# SYDNEY METRO PITT STREET SOUTH OVER STATION DEVELOPMENT

Response to RFI (SSD 10376 &  
SSD 8876-2)

12 November 2020

**Figure 2** Illustration of Location of Windows and Balconies

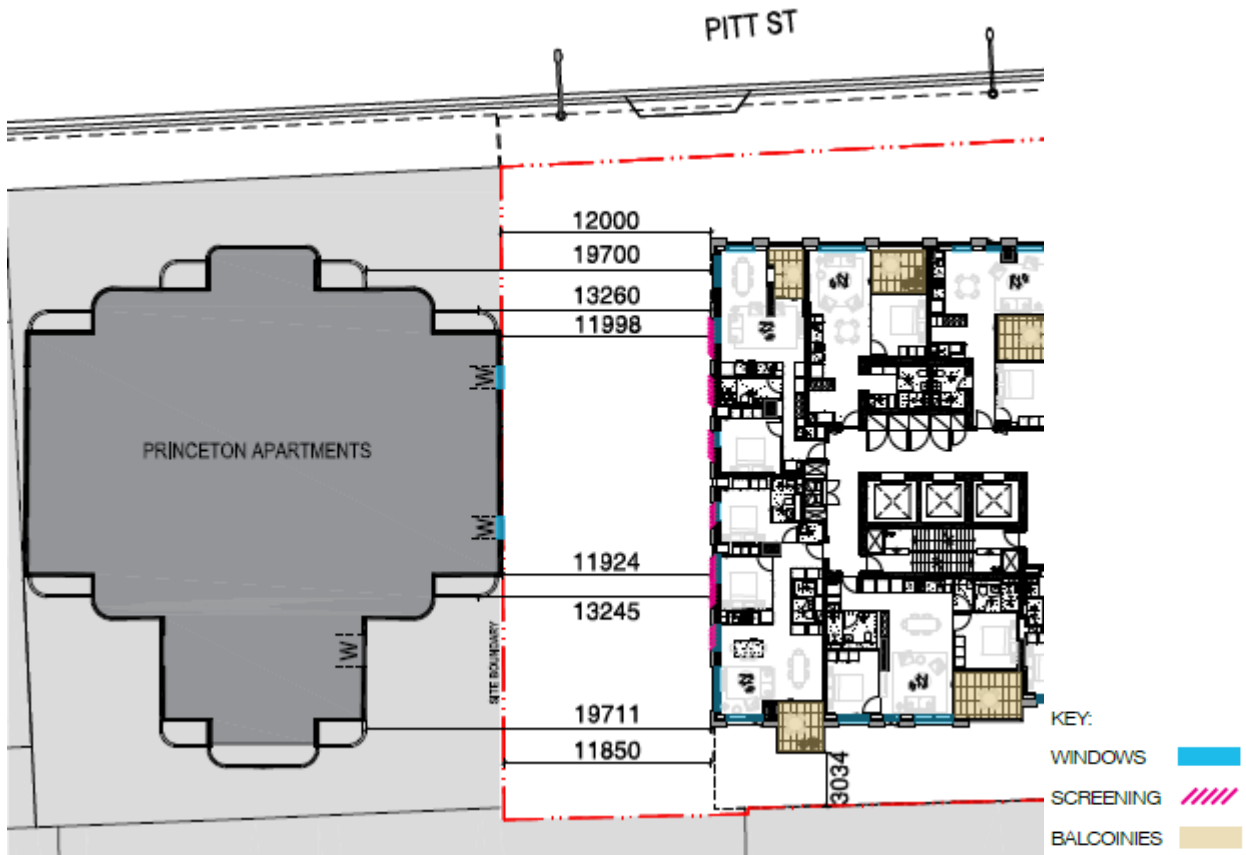
The DPIE have requested that the applicant demonstrates a reasonable level of privacy will be maintained between the proposed building and Princeton Apartments. Please refer below (included at **Appendix A**) to an illustration of both buildings and the location of windows and balconies within this setback zone.

As demonstrated below, all operable windows proposed on the site are located in excess of 12m from the Princeton Apartments. Further windows without screens are offset from the north facing windows of the Princeton Apartments, and also to the narrow side of any balconies on Princeton Apartments to protect existing privacy to these areas.

**Figure 3** Minimum eastern boundary setback

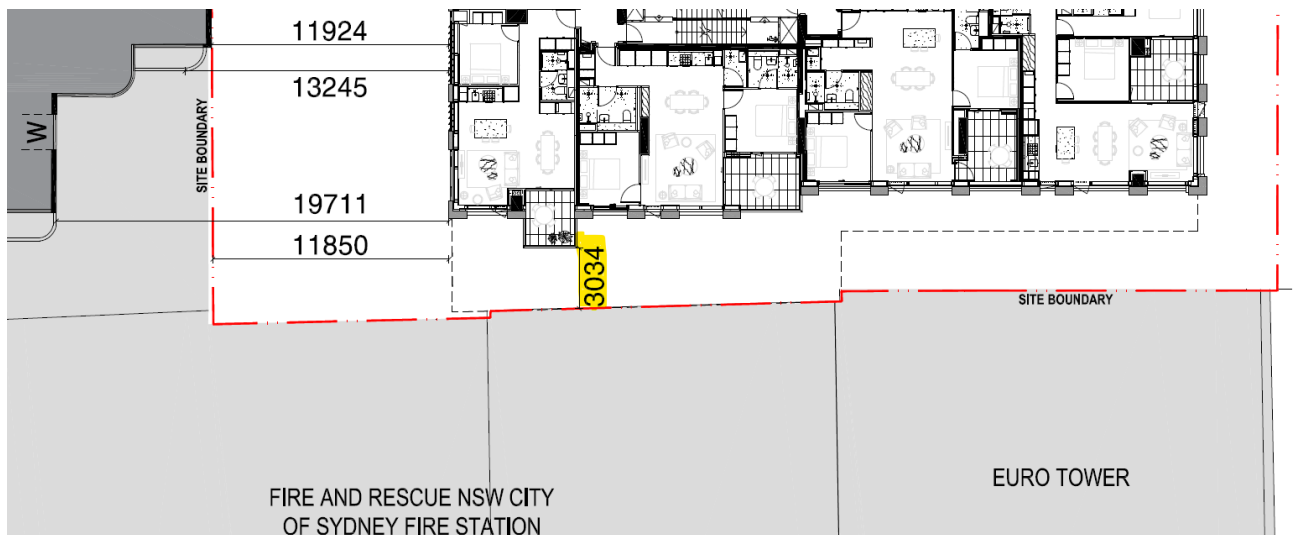
The DPIE have requested further confirmation that the amended development complies with the 3m setback requirement from the eastern (rear) boundary. Please refer below (included at **Appendix A**) to an illustration clearly demonstrating that the proposed development complies with a minimum 3m setback to the eastern site boundary.

**Figure 4** Location of EOT facilities for retail workers on Level 2

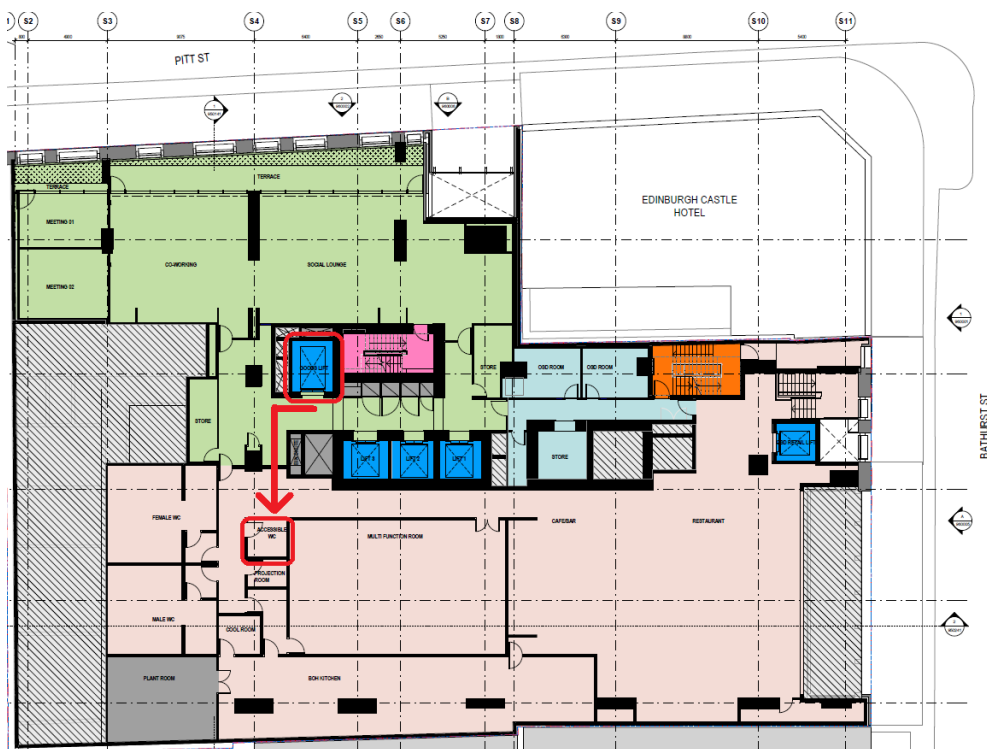
The DPIE have requested confirmation on how the proposed 12 retail bicycle parking spaces will be accommodated within the development.

Within the RTS it was proposed to have the 12 retail bicycle parking spaces within the retail use on Level 2. This has been reviewed from an operational perspective and confirmed that it is more effective to house these bicycles with the resident bicycles on the Level 3 – Bike parking and apartment storage level.

The amended design provides EOT facilities for retail workers on Level 2 consisting of an accessible bathroom which will include a shower for retail employees. With the retail bicycles able to take the same route with the residents' bicycles, the route is accessible from the goods lift, illustrated in the following figure.

**Figure 5** Edinburgh Castle Hotel Development Options

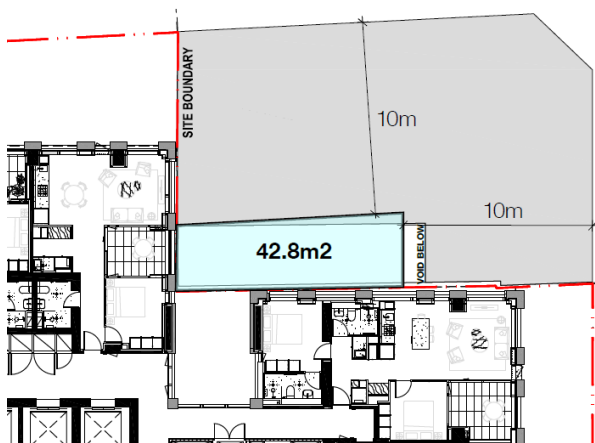
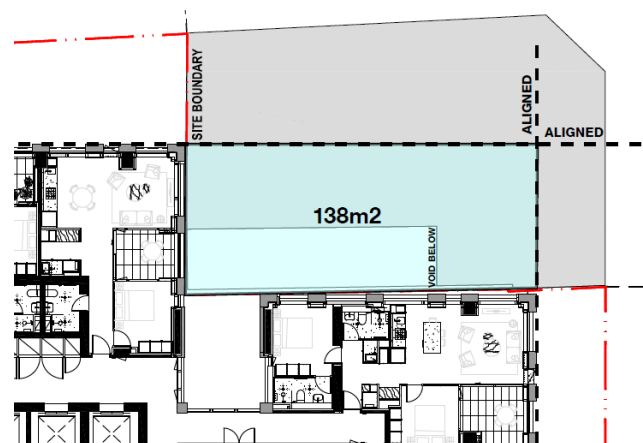
The DPIE have requested confirmation on how light and air will be secured to the bedroom and balcony of the typical one-bedroom unit located immediately to the south of the Edinburgh Castle Hotel southern site boundary in the event that the Edinburgh Castle Hotel is comprehensively redeveloped in the future.

- Once the Sydney DCP-required upper level setbacks above a heritage item (10m) are provided the remaining site area available for built form is limited to 42.8sqm. While it is considered unlikely above a heritage item, if the City of Sydney were to consider variation to the 10m upper level setback control, the maximum floor plate likely to be supported above the existing building is 138sqm, with setbacks aligning to that of the proposed OSD building.

- The diagrams included below demonstrate that a complaint floorplate above the heritage listed Edinburgh Castle Hotel (in this case, above an existing void on the site) would be significantly constrained such that it would be an unviable development proposition.
